Monitoring Report- Year 3
FINAL VERSION
Pen Dell Mitigation Project
Calendar Year of Data Collection: 2020

NCDEQ DMS Project Identification # 97079
NCDEQ DMS Contract # 6824
Neuse River Basin (Cataloging Unit 03020201)
USACE Action ID Number: SAW-2016-00885
NCDEQ DWR Project # 2016-0403
Johnston County, NC
Contracted Under RFP # 16-006477
Data Collection Period: September-October 2020
Submission Date: December 11, 2020

RE: WLS Responses to NCDEQ DMS Review Comments for Task 9 Draft Monitoring Report Year 3 for the Pen Dell Mitigation Project, NCDEQ DMS Full-Delivery Project ID #97079, Contract #006824, Neuse River Basin, Cataloging Unit 03020201, Johnston County, NC

Figure 5: Monthly Rainfall Data
Pen Dell Mitigation Project (NCDEQ DMS Project ID# 97079)
MY3 2020

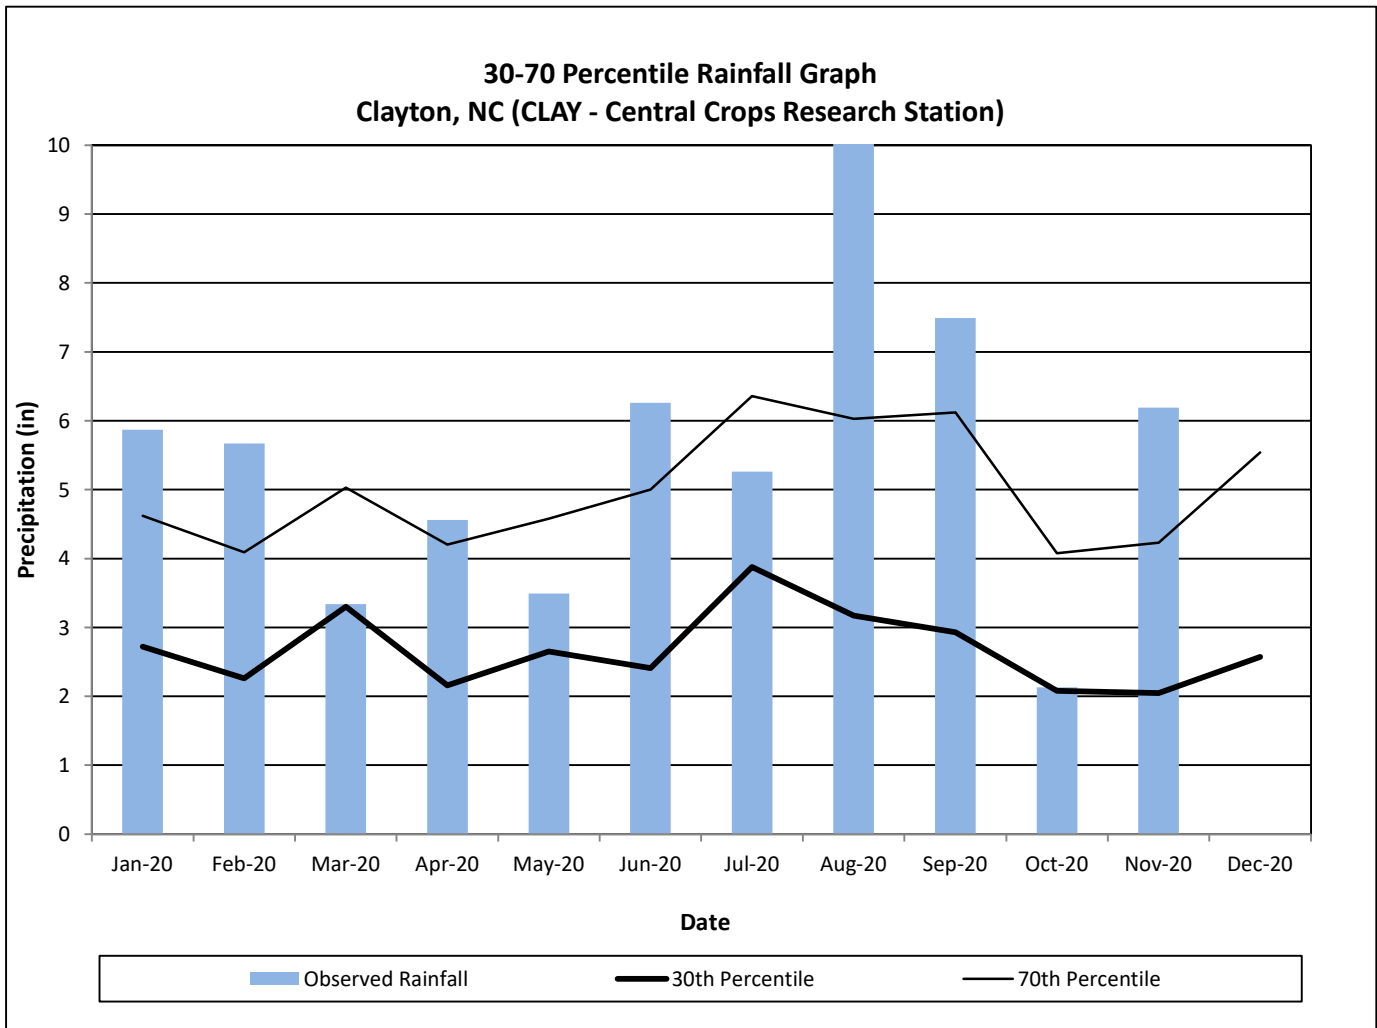
- 2. DMS Comment: Update rain report for October and November if possible.** WLS Response: WLS updated Figure 5 with the October and November rain total.
